## FORT DONELSON MONUMENT COMMITTEE 2024 REPORT

April 15, 2024

**SUPPLEMENTAL INFORMATION FOR THE  
STATE OF NEBRASKA’S PROPOSAL  
TO PLACE A MONUMENT AT THE  
FORT DONELSON NATIONAL BATTLEFIELD  
TO HONOR THE ROLE THE FIRST NEBRASKA VOLUNTEER INFANTRY  
PLAYED IN THIS VERY SIGNIFICANT BATTLE**

**Figure 1**  
 Map by the Southeast Archeological Center showing scaled overlay of proposed monument and associated infrastructure and location of new area under consideration for possible line of First Nebraska Volunteer Infantry. (Southeast Archeological Center)

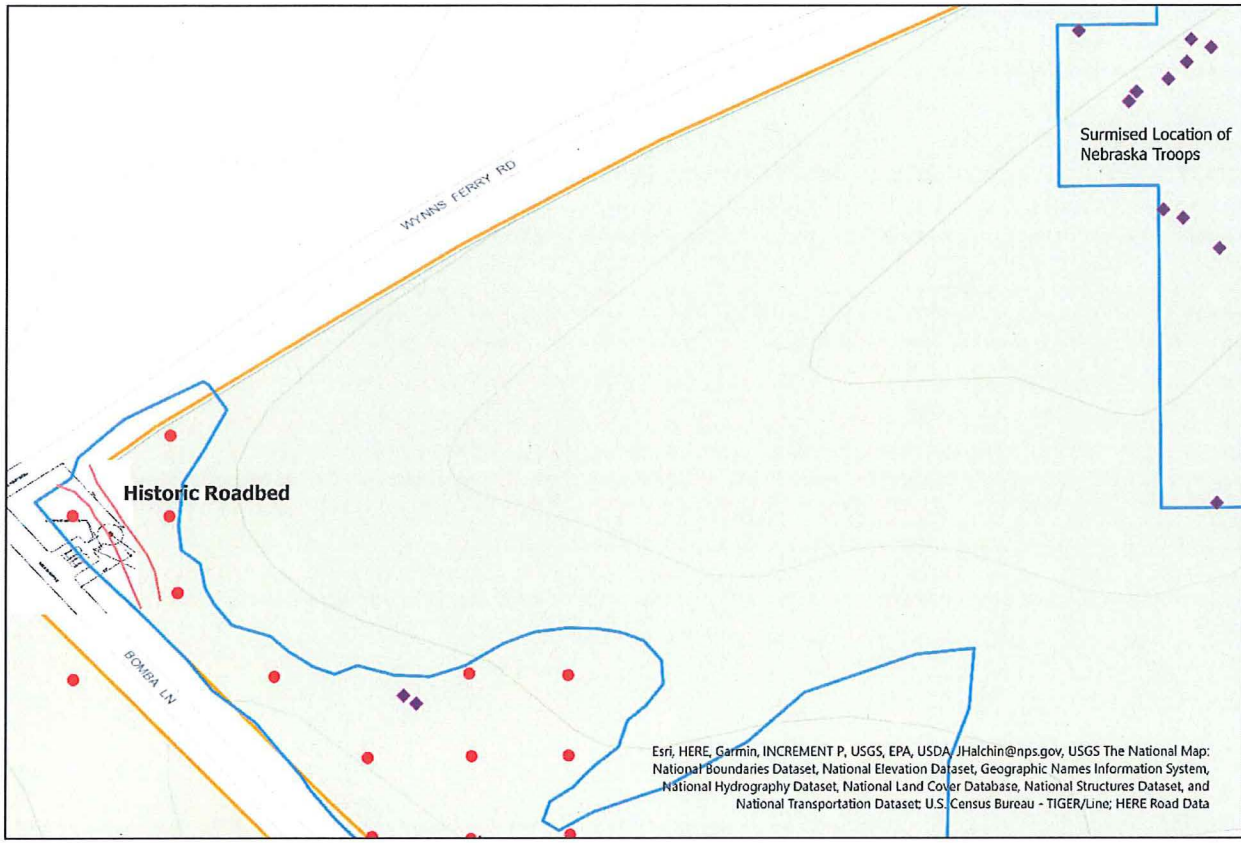
While the precise location of the battleline is unknown, recent archeological and geophysical survey suggest its location may be as far as 700 feet forward, to the east/northeast of the previous area of focus. This emerging information may impact the suggested location, should it no longer be believed to be the actual vicinity to the battle activities that the proposed monument is to interpret and commemorate.

At my request, the SEAC team moved forward, surveying eastward and down the slope, approximately 240 yards, before finding dropped bullets in a somewhat linear line. Initial hypothesis by the archeologists is that this may be an indication of the sought-after defensive line of February 15, and, with proximity to the Wynn’s Ferry Road that the First abutted, the actual position of the unit. Further on-site archeological and geophysical analysis is planned for this year.

As per above, analysis of data obtained by archeologists suggests that the location associated with the First Nebraska may be 240 yards to the east/northeast, placing it in closer proximity to the eastern terminus of the Nelson Circle loop, and relatively close to a private residence, located at the southwest corner of the Wynn’s Ferry and Nelson Circle intersection (Figure 2). Pending a more confident determination, should the NPS and/or Committee propose an alternative location, the same consideration should be given to the above-mentioned resources, as well as topography, vehicular access, accessibility, and potential visitor impacts upon neighbors.

As current archeological work suggests that the actual line may have been more than two hundred yards to the front, assessment on the part of the Committee and/or NPS for an alternative location may be warranted. The park can provide images or reference material for other locations, upon request.

The Committee greatly appreciates the efforts of Superintendent McCutcheon and the NPS Southeast Archeological Center to identify, as closely as possible without the benefit of any eyewitnesses, the location of the Thayer Brigade battle line. The location identified in Nebraska’s original Proposal was based on what the Committee believed to be the best historical information available at the time. There is better information available now. Nebraska is open to the modification of its Proposal to locate the monument in a location that is most relevant to the most current historical and archeological information. We propose at this time to agree to work with the NPS to come up with the most appropriate location for Nebraska’s proposed monument, with off-road parking and walkways to be adjusted accordingly.

**Figure 2**  
 Bears battle unit map for February 15, 1862, overlaid with proposed monument location, documented historic road, areas of survey, and vicinity under assessment as possible battleline location. (Fort Donelson NB Map)

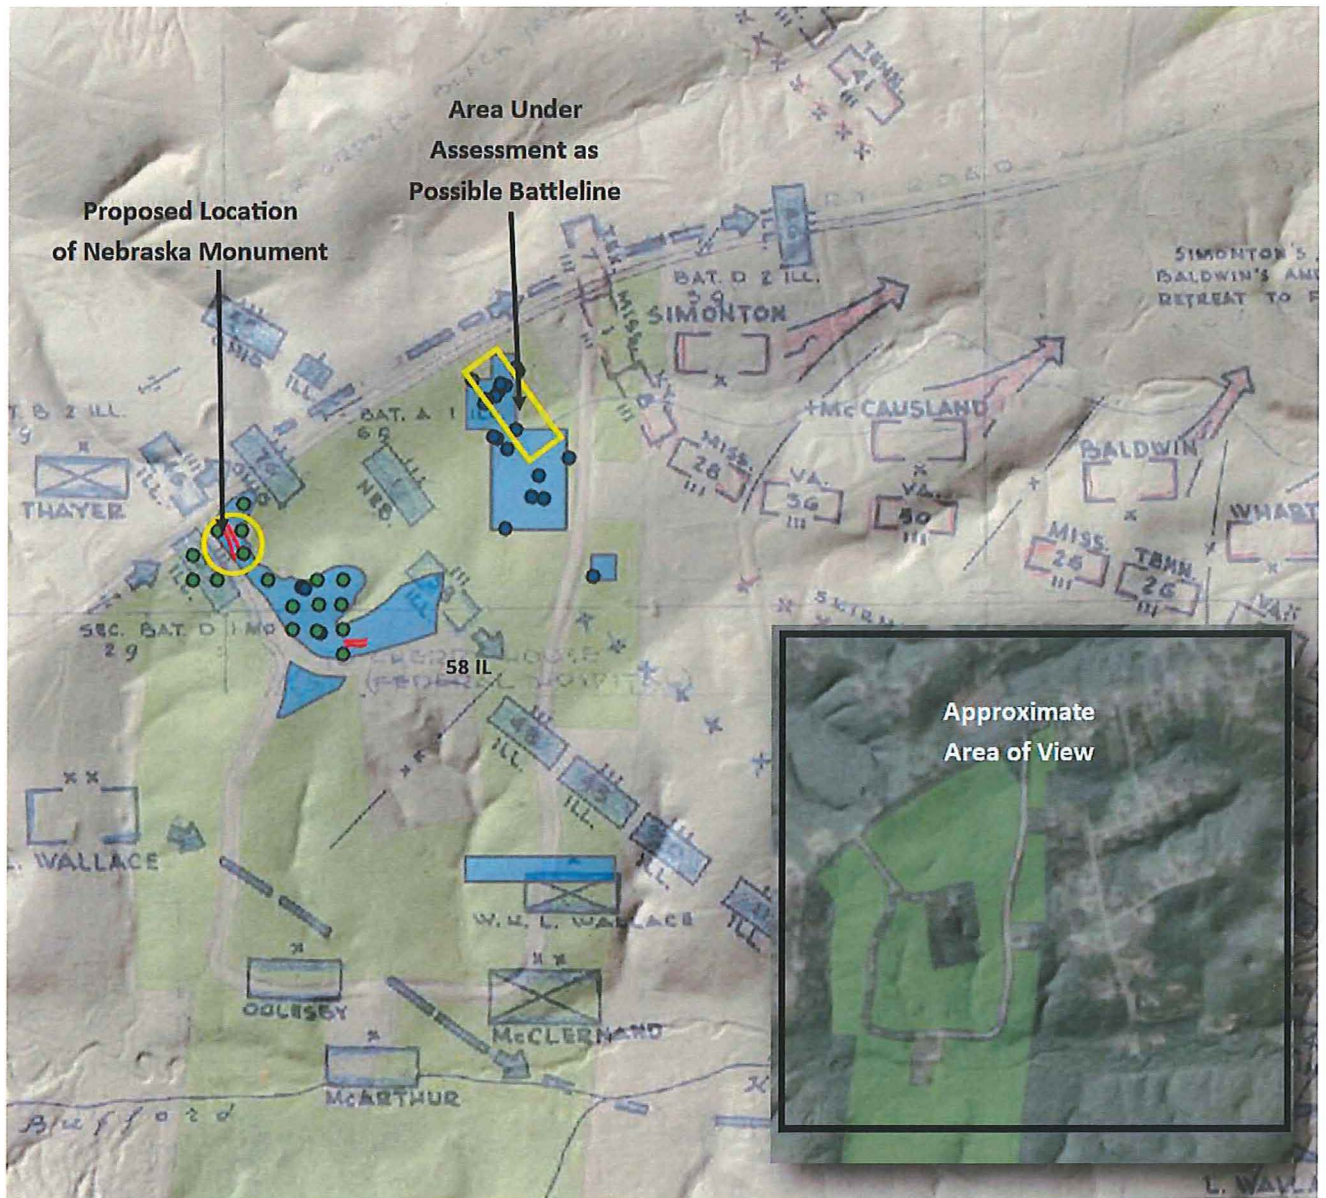
To better address the monument proposal and seek evidence of location of the Union line of defense – most specifically that of the First Nebraska—the NPS Southeast Archeological Center (SEAC) conducted extensive archeological geophysical survey of the area in 2023, starting at the proposed monument location and extending southward (Figure 1). In this sector, nothing of historical association was found, although SME determination that a linear depression that parallels the modern Nelson Circle, long theorized by the park to be a historic road trace, is likely the 1862 period road for this vicinity identified on period maps.

Figure 3  
Fort Donelson NB exhibit panel intended for the location of the proposed First Nebraska monument.

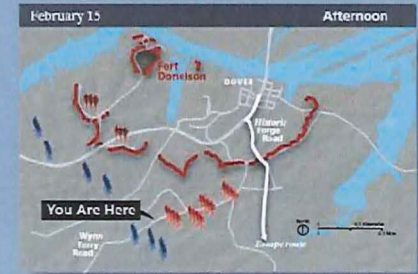
An alternative to a Nebraska provided interpretive panel would be for the NPS to install a wayside panel, part of the park's updated Wayside Exhibit design plan, telling of the same period of battle and intended for the same location (Figure 3).

Upon consideration of your response, the Committee feels its proposal should be altered regarding interpretation. The language for the interpretive panel originally proposed by the Committee was actually composed when the thought was that there would *only* be the interpretive panel, and no monument – the Battlefield Superintendent prior to Superintendent McCutcheon had suggested that an interpretive panel would be more favorably considered than a monument. However, the State of Nebraska, through its Legislature and Governor, proposed the erection of a monument. The Committee thought both the panel and a monument might be appropriate. The Committee is happy to scale its proposal back and delete the proposed interpretive panel in favor of the proposed wayside panel set forth as Figure 3 in the NPS’s response. Instead, the committee now proposes that bronze plaques be attached to the sides of the concrete base for the statue. The plaque on the front of the base, most likely the side under the face of the depicted soldier, would be approximately two feet long and ten inches high, and would simply say “Nebraska,” much like the 2015 Mississippi monument at Shiloh. The Committee proposes a second plaque, on the side below the soldier’s back, approximately two feet square, that will

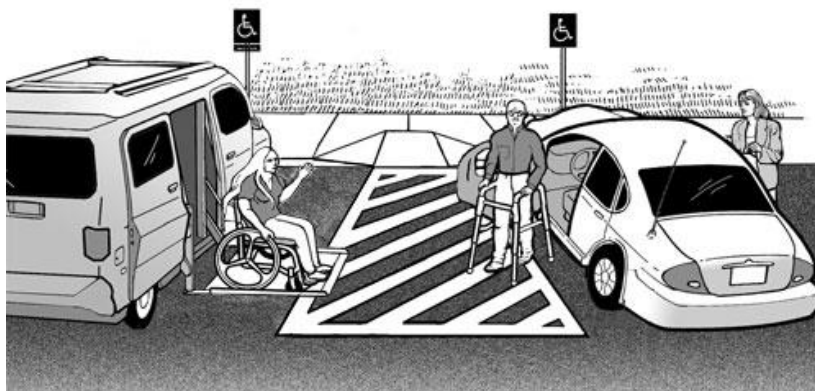
While the provided schematic is preliminary, dimensions of parking, intended width and length of walkways for necessary accessibility, and whether one or both provided parking spaces are intended for handicap designated parking are needed.

Of note, the document indicates intent to place pavers like those utilized in other areas of Fort Donelson. It is requested that concrete walkways be considered. The park is currently in the planning stage for removal of the difficult to maintain pavers and their replacement with paved, handicap accessible walkways.

Nebraska proposes a parking area for two, handicapped access, parking places. The United States Department of Justice recommends specifications for such a parking area. There would be two spots for vehicles, each eight feet wide and twenty feet long, with a common access area in between the stalls that is five feet wide. Thus the entire parking area would be twenty-one feet wide and twenty feet long. Paint on the stalls and signage would be as required. Here is a drawing from the ADA.gov website:

The surface would be concrete, and there would be a handicapped accessible concrete walkway to the monument.
